Access Compliance Report

Public Rights-of-Way

(Curb Ramps)

Intersection ID: 16897	Main Street: MONTAGUE_ST	Cross Street: SUMMEY_AV	Location: W
ADA ID: 6CDBF810DF0E	Ramp Type: Para	Initial Pass/Fail: Fail	Overall Compliance: No
Severity Score: 12.5			
Codes/Mitigation Info/Possible Solution		Field Measurements/Component Compliance

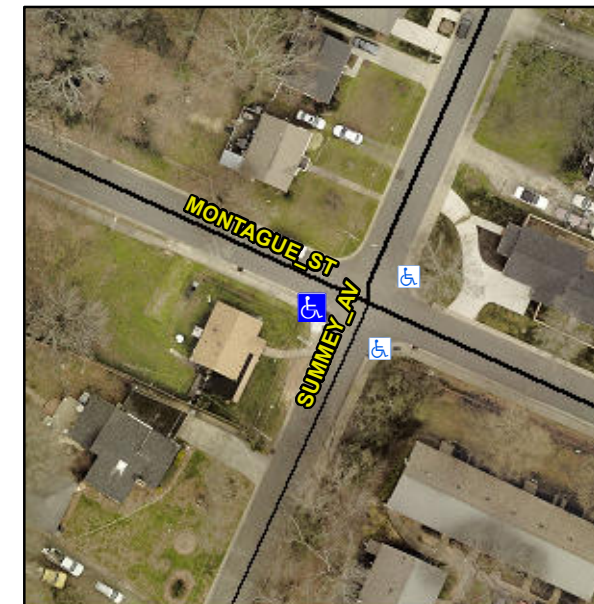
RT RP < 5%

R304.3.2

Compliance	Description	Data	Compliance	Description	Data
N/A	Ramp Length LT (in)	34.0	N/A	Ramp Length RT (in)	54.0
Yes	Ramp Width LT (in)	61.0	Yes	Ramp Width RT (in)	59.0
No	Ramp Slope LT (%)	9.1	Yes	Ramp Slope RT (%)	2.1
Yes	Ramp XSlope LT (%)	0.4	Yes	Ramp XSlope RT (%)	1.4
N/A	Landing Length (in)	N/A	N/A	DWS Provided?	N/A
N/A	Landing Width (in)	N/A	N/A	DWS Contrast?	N/A
N/A	Landing Slope (%)	N/A	N/A	DWS Length (in)	N/A
N/A	Landing X Slope (%)	N/A	N/A	DWS Full Width?	N/A
N/A	Landing Curb? (Y/N)	N/A	N/A	DWS Offset (in)	N/A
N/A	Shared Landing?	N/A			
N/A	Gutter Ponding?	N/A	N/A	Gutter Slope (%)	N/A
N/A	Gutter Lip Ht (in)	N/A	N/A	Gutter X Slope (%)	N/A
N/A	Painted X Walk1?	No	N/A	Painted X Walk2?	N/A
	X Walk 1 Direction	To SE		X Walk 2 Direction	N/A
N/A	X Walk 1 Width (in)	N/A	N/A	X Walk 2 Width (in)	N/A
	X Walk 1 Slope (%)	2.1		X Walk 2 Slope (%)	N/A
	X Walk 1 X Slope (%)	2.7		X Walk 2 X Slope (%)	N/A
N/A	Ramp inside XWalk1?	N/A	N/A	Ramp inside XWalk2?	N/A

Possible Solutions:

Remove & Replace Entire Ramp.
